HISTORIC RESOURCES PRESERVATION BOARD REPORT

HRPB Project Number 23-00100112: Consideration of a Certificate of Appropriateness (COA) for the construction of a new $\pm 1,881$ square foot single-family house and a new ± 693 square foot detached garage at 224 North L Street. The subject property is located in the Medium Density Multi-Family Residential (MF-30) zoning district and has a future land use designation of High Density Residential (HDR). The property is a contributing resource in the Northeast Lucerne Historic District.

Meeting Date: June 14, 2023

Proposed Front Elevation

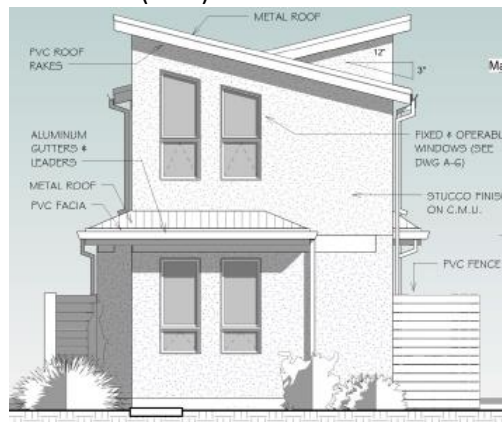
The main massing of the structure utilizes multiple shed roofs in contrasting angles, and the detached garage utilizes a gable roof. Both structures proposed hipped roofs above the first story of the buildings. Staff contends that these proposed rooflines create a confusing, cluttered design and do not successfully emulate a Contemporary design. Staff recommends revising the roofline of the primary structure to be a shed roof with a single slope (this would require some alterations to the proposed windows on the second floor), or changing the middle section of the roofline from a shed roof to a flat roof. Staff also recommends revising the hipped roof above the first floor to be a simple, flat roof above any porches or areas that the second story is recessed from the first story's exterior walls. Additionally, the depth of the first-story roofs should be revised so that it is consistent across the structures' elevations. The proposed gable roof on the accessory structure should be changed to a simple flat roof or a shed roof to match that of the primary structure. These revisions would simplify the design, make its Contemporary influence clearer, and, in the case of the flat first-story roof, would help emphasize horizontality in the design, which was common in Contemporary and Mid-Century Modern architecture.

Finally, staff has concerns about the proposed design of the front façade. Staff contends that the current design reads more like the side of a building facing the street, rather than the front of a house. While some homes nearby have their primary entrances on the side of the building, they all have sufficient detailing and architectural features to read as the front façade. Staff recommends that the applicant either revise the proposed design to place the entry door on the front façade, or add architectural interest to better emphasize the front façade.

- 1) The main roofline of the primary structure shall be revised to make the middle section a flat roof, or to make the entire roof a shed roof with a single slope.

- 4) The front façade of the primary structure shall be revised to include the entry door and/or architectural detailing to emphasize it as the main façade of the building.
